Model: General RTB	Date: 4-Feb-03	No.: RGene013b
--------------------	----------------	----------------

Subject: Service remarks at installation		Prepared by: T. Itoh	
From: Technical Service Sec. Service Planning Dept.			
Classification:	<input type="checkbox"/> Troubleshooting	<input type="checkbox"/> Part information	<input type="checkbox"/> Action required
	<input type="checkbox"/> Mechanical	<input type="checkbox"/> Electrical	<input type="checkbox"/> Service manual revision
	<input type="checkbox"/> Paper path	<input type="checkbox"/> Transmit/receive	<input type="checkbox"/> Retrofit information
	<input checked="" type="checkbox"/> Other (Specification change)

Model: Adonis-C3		Date: 28-Mar-03	No.: RB082001
Subject: Page sequence of PCL booklet print job becomes strange		Prepared by: Nobutaka Hanaoka	
From: Overseas DTS Sec. Service Planning Dept.			
Classification:	<input type="checkbox"/> Troubleshooting <input type="checkbox"/> Part information <input type="checkbox"/> Action required <input type="checkbox"/> Mechanical <input type="checkbox"/> Electrical <input type="checkbox"/> Service manual revision <input type="checkbox"/> Paper path <input type="checkbox"/> Transm

5.1.7 Retrieving the Debug Log (Page 5-84)**DELETE the following:**

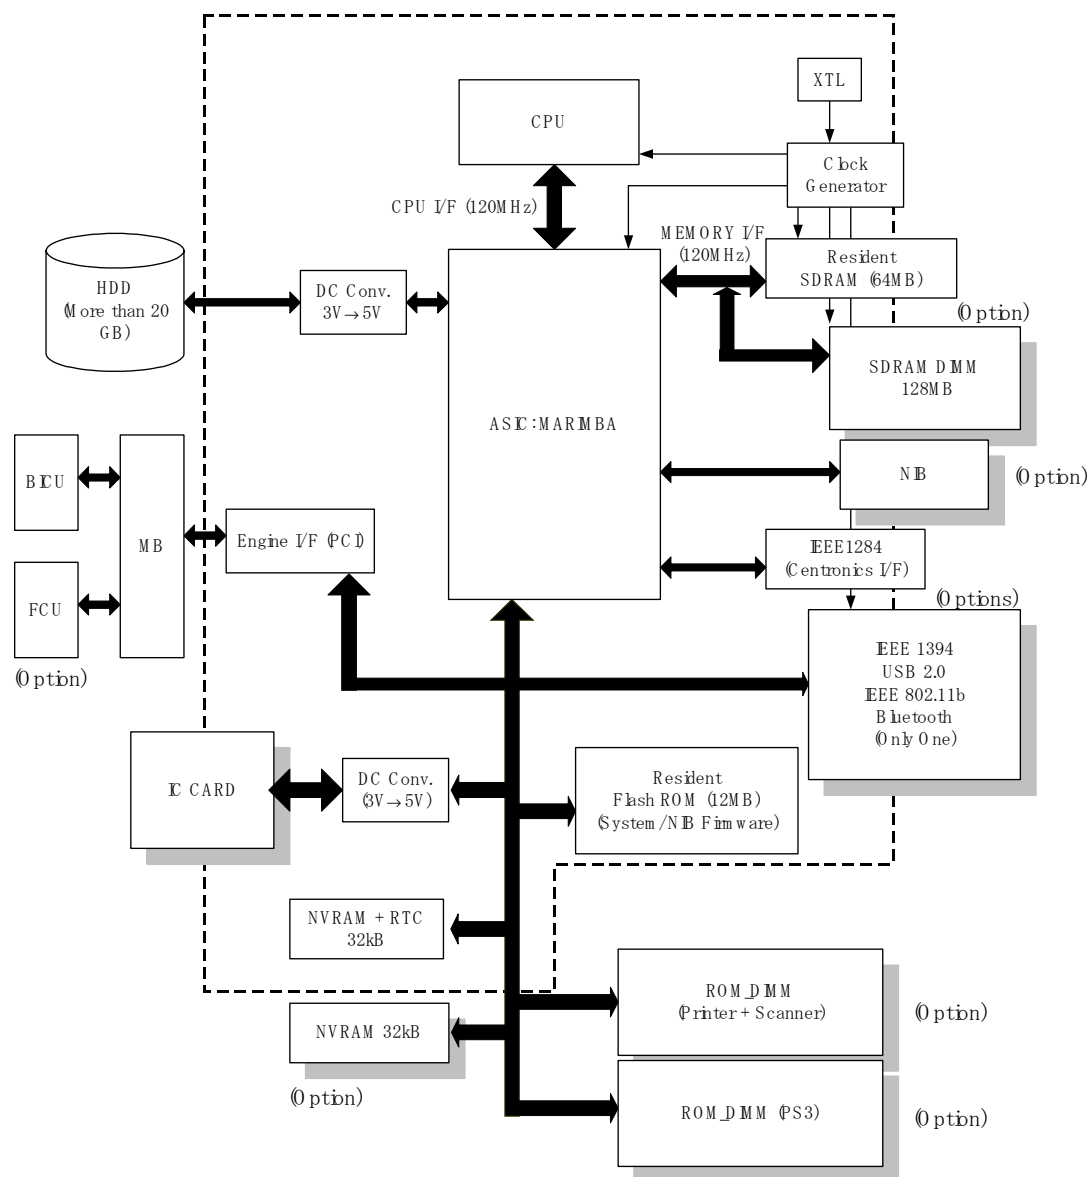
NOTE: 1) *The program converts binary file to a text file in the same directory.*

2) *The target file name for the text file is generated automatically.*

3) *If the debug log was copied to an IC card of the wrong format, then an error is issued and the program halts.*

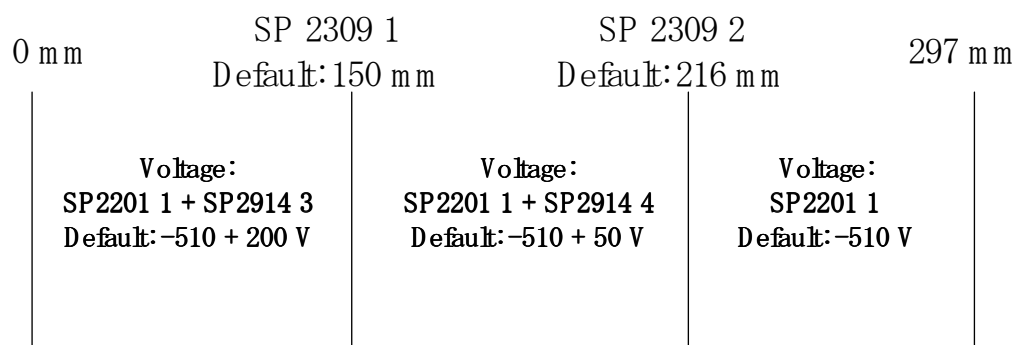
REVISE as follows (underlined portions), including the corresponding values in the illustration:

SP Mode	SP Name	
SP2201 1	Development Bias	Width 216 - 297 mm (Default: <u>-510</u> V)
SP2309 1	Paper Lower Width [a]	Width limit (Default: 150 mm)
SP2309 2	Paper Upper Width [b]	Width limit (Default: 216 mm)
SP2914 3	Process Control Setting (B γ)	Adjust 10V/step (Default: <u>200</u> V)
SP2914 4	Process Control Setting (B δ)	Adjust 10V/step (Default: 50V)

4.1.2 SC Code Descriptions (Page 4-2)

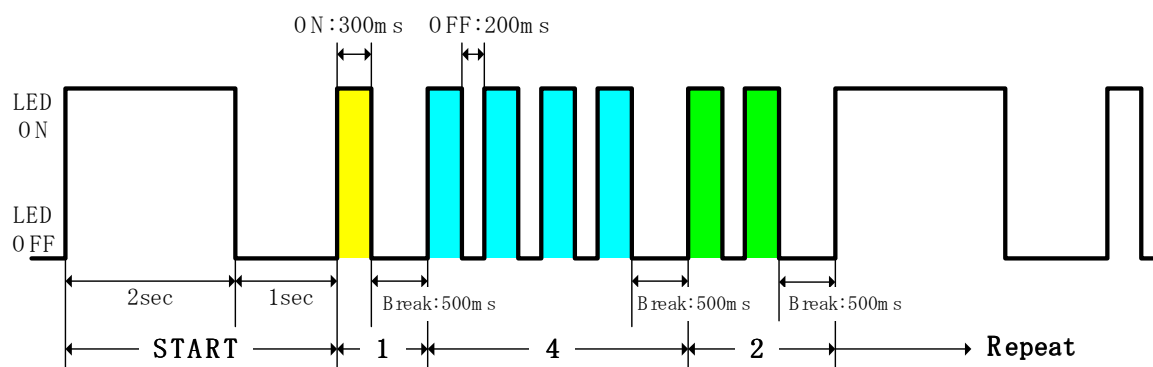
The following describes the method for using the LED to read the details for SC740/741 (Booklet Finisher-related errors), as this information is not displayed on the machine operation panel. The new descriptions for the Service Manual begin from the following page.

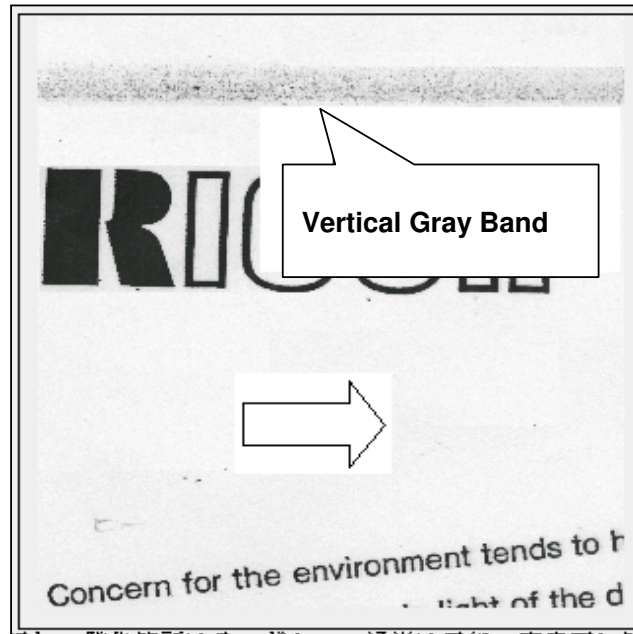
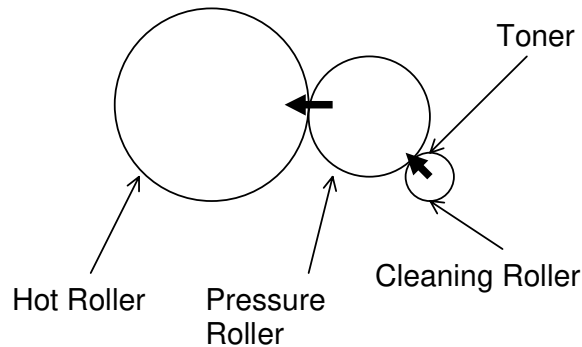
Random **gray band(s)** (both sides) or fusing wrap-around jams due to cleaning roller toner melting, mostly on the 45cpm model.

1. Replace the cleaning roller.
2. If the fusing temperature (SP1105-001, -002) had been set higher than default, return it to its default value.
 - However, if the fusing temperature is being set above default as a solution to cold offset, simply make sure this temperature does not exceed the following:

- ✧ 35cpm: Maximum increase of +10C
 - ✧ 45cpm: Maximum increase of +5C
3. Check the lot number printed on the toner bottle being used in the machine, and replace the bottle if it is older than the following.

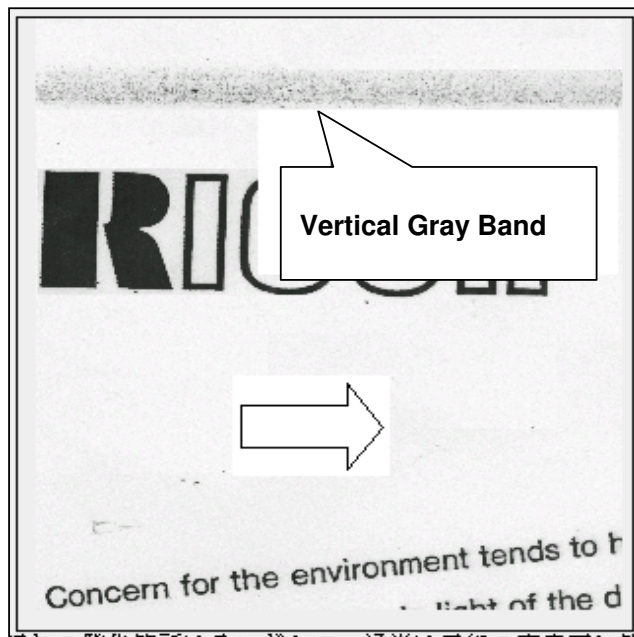
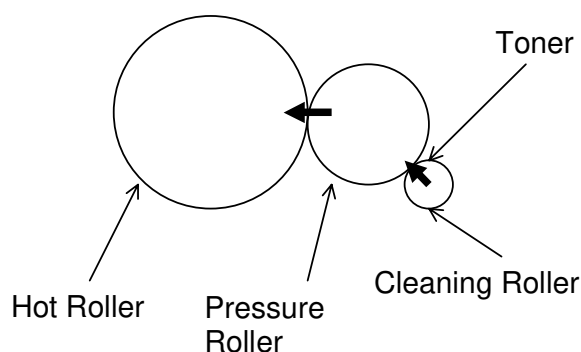
The cleaning roller was modified to further improve the level of gray bands. Please note that the Solution below was also changed.

Random ***gray band(s)*** (both sides) or fusing wrap-around jams due to cleaning roller toner melting, mostly on the 45cpm model.

2. Replace the fusing cleaning roller with AE042070

- **DO NOT** clean the new roller.
 - **DO NOT** cut, shave or try to change the surface of the roller.
- If you do, the new coating on the roller will come off.*

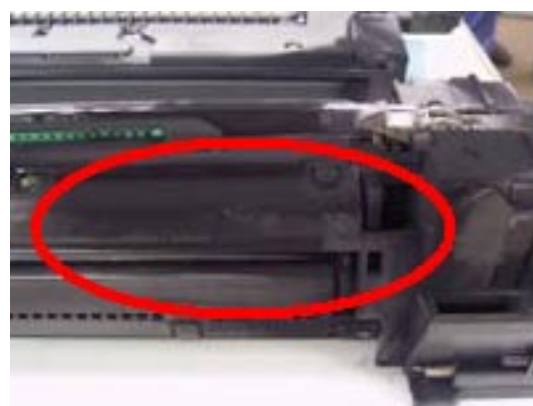
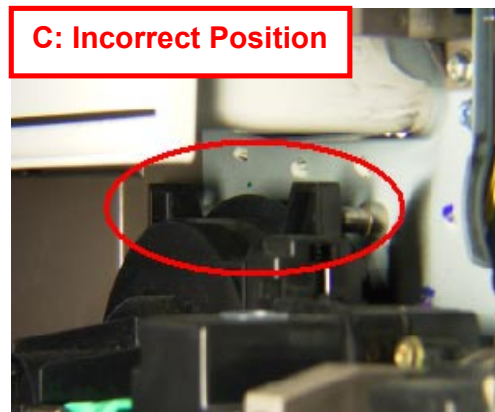
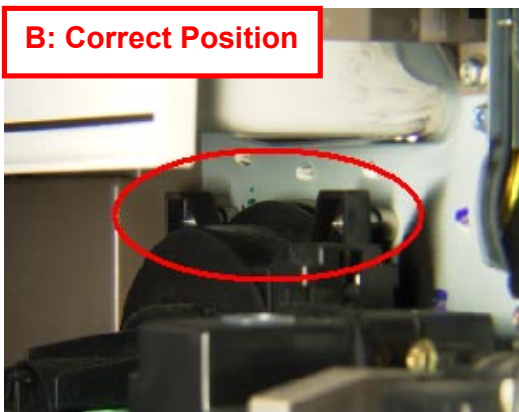
Toner scattering occurs around the PCU and on the inside/outside of the front cover.

The operator pulls down the green lever for the toner hopper unit before they push the toner hopper unit into the machine.

- If the operator makes this error, it looks like the toner hopper unit is set correctly (see photo A). However, the positioning pins in the machine do not go inside the holes in the toner hopper unit.
- As a result, the PCU is not aligned with the toner supply window and the new fusing cooling fan (added from A-C3) scatters the toner inside the machine.
- The correct operation is to: 1) Push the toner hopper unit all the way in, and then 2) Pull down the lever.

- 1) Re-install the toner hopper unit correctly.
- 2) Clean the inside of the machine.
- 3) Show the customer the correct way to install the toner hopper unit.
